June 26, 2003

To: Compatible Electronics TCB

We have been informed by Ruby Hall, of Compatible Electronics, that there is an issue with placing the FCC ID for our newest presentation remote on its battery cover. We now understand why the FCC might have a concern with the FCC ID being on the battery cover - i.e. the battery cover could get lost while the still functioning remote continues to need to have a visible FCC ID on the unit.

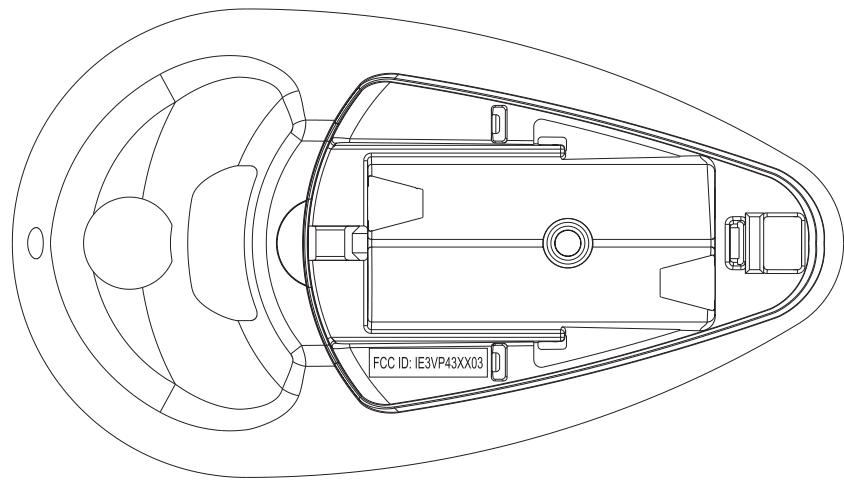
Our problem is that there is no other suitable location for the FCC ID on the exterior of the product due to its size, shape, and surface finishes. We have, however, a proposal that we think solves this problem and fully addresses the FCC's concern for having the FCC ID always visible on the product.

We propose to leave the FCC ID on the main product label that is affixed to the battery cover, AND, in addition, affix a second FCC ID label inside the battery compartment (see attached drawing). This location is not covered by the batteries and is, therefore, visible anytime that the battery cover is not in place. When the battery cover is in place, the original FCC ID is clearly visible on the battery cover label.

In summary, one of the two FCC ID labels is visible under any condition. (We would like to later replace the FCC ID label inside the battery compartment by etching the FCC ID lettering directly into the tooling for the plastic case part in this same location.)
